REQUEST FOR INFORMATION	DATE: September 28, 2016	NO.: RFI-302
--------------------------------	---------------------------------	---------------------

Project Name: 15051-Webster University Interdisciplinary Science Building	Project No.: 15051
---	--------------------

Subject: Clarifications from stair detailer

Stair #1-

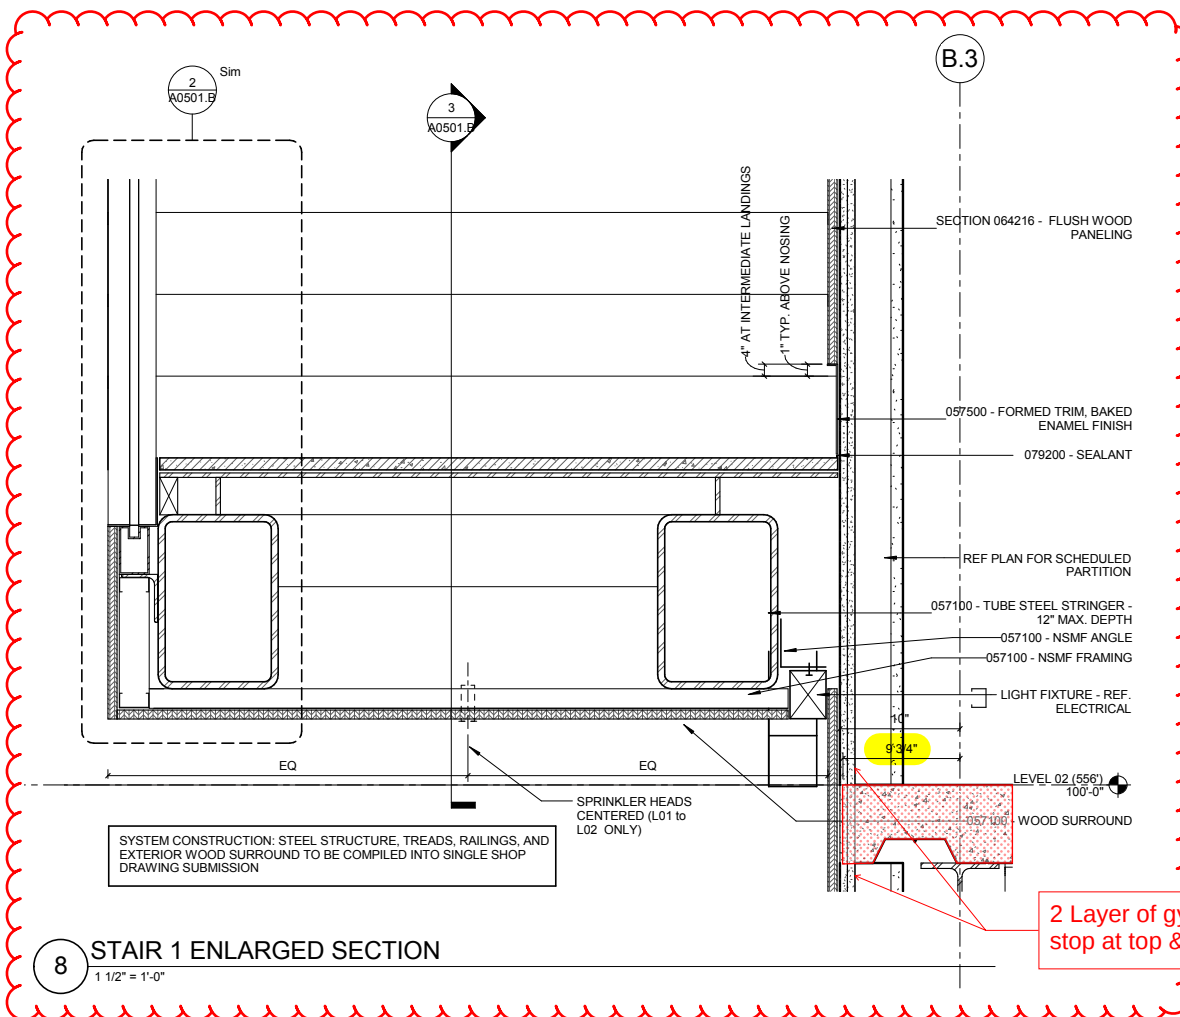
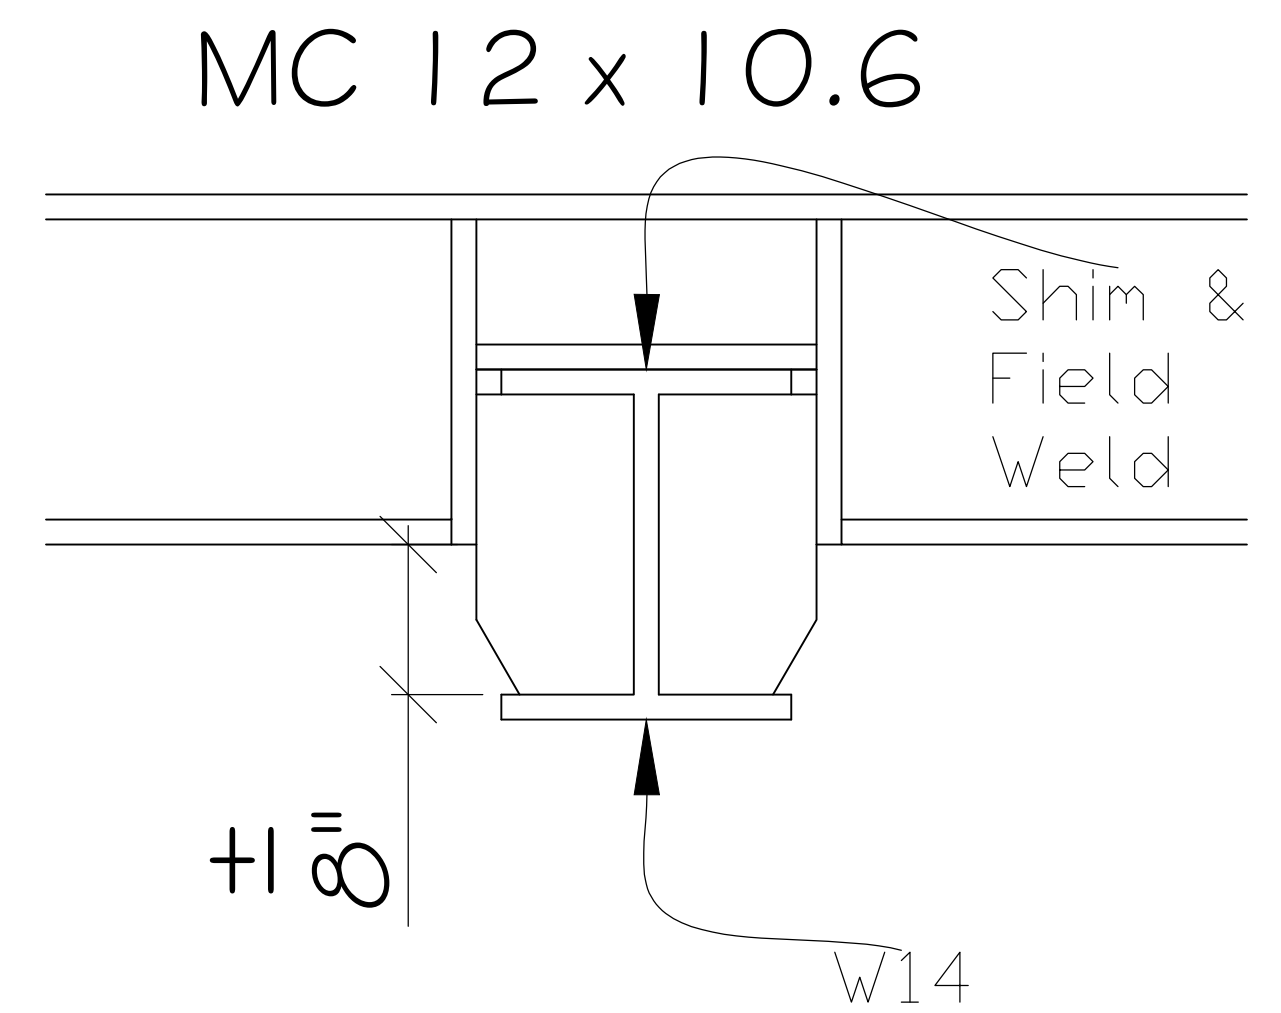
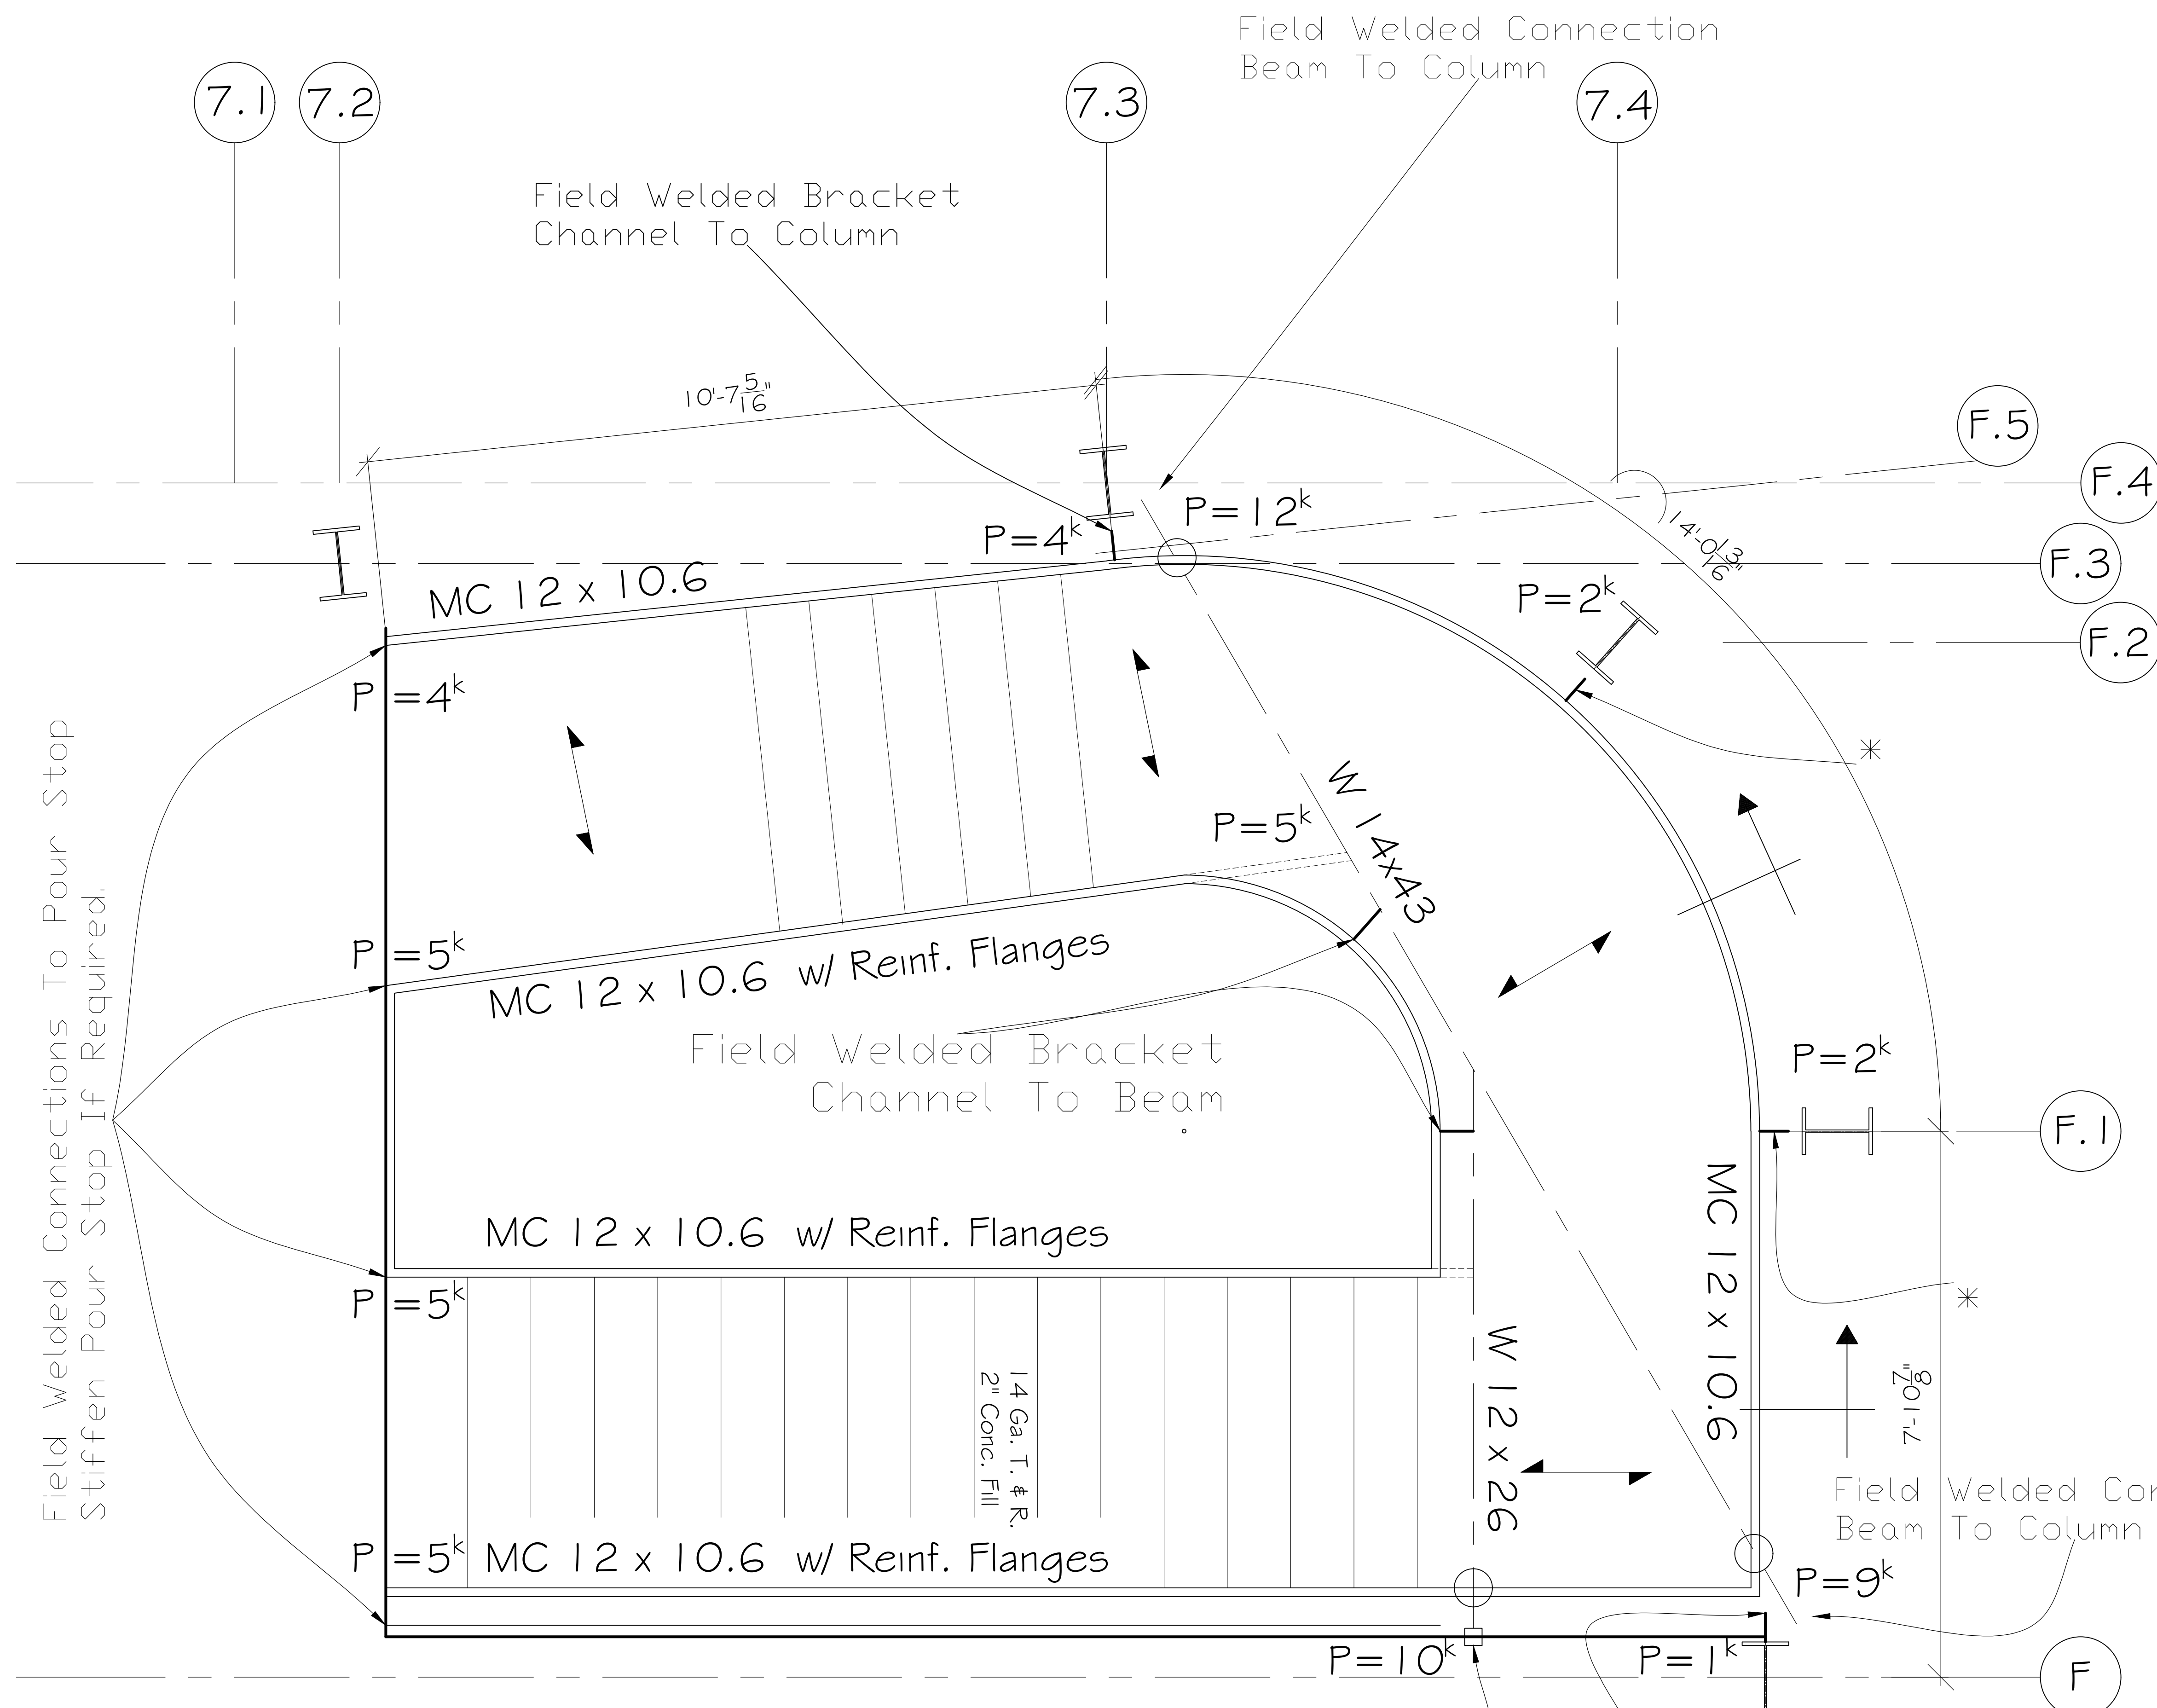
Stair #1

(A) There are some differences between architectural and structural drawings. We've primarily used structural dimensions and details and noted the resulting dimensions to the finishes. These need to be verified.

(B) This stair specification (057100) does not call for any specific design criteria. We've noted what we're using. We've also noted the resulting 'total load' deflections in each individual member. Verify the stair construction and resulting deflections are adequate for the finishes (precast treads, landings, glass rails, wood, etc.)

The EOS from grid B.3 is 9 3/4" per structural and architectural detail 8/A0501.B (see below). The 10" dimension is to the face of the 2 layer of gypsum boards, which will stop at the top & bottom of slab.

GC to coordinate between various systems. The structural performance should meet the requirements of other systems (Glass railings, Precast terrazo...etc.)

Section @ Landings

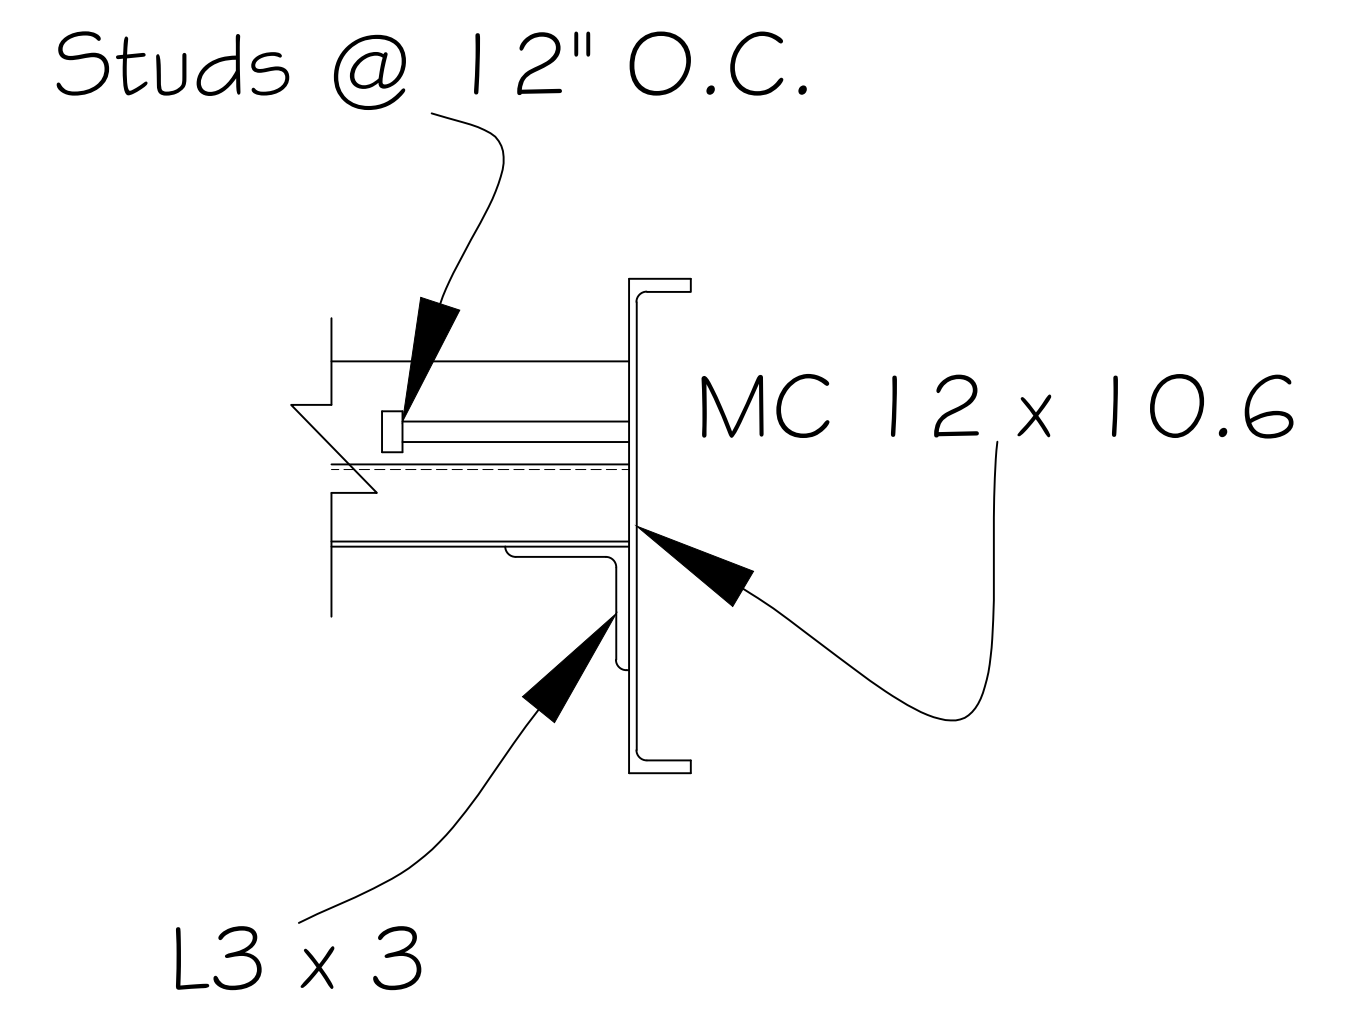
Stair #2

(A) The shown member sizes produce deflections less than the spec'd. 1/4" in each individual member.

Proceed per discussion in meeting on Oct. 3rd (at CannonDesign) with Paric (Jason), Atlas (Guy) & Lasalle (Larry).

Proceed per discussion
in meeting on Oct. 3rd
(at CannonDesign) with
Paric (Jason), Atlas
(Guy) & Lasalle (Larry).
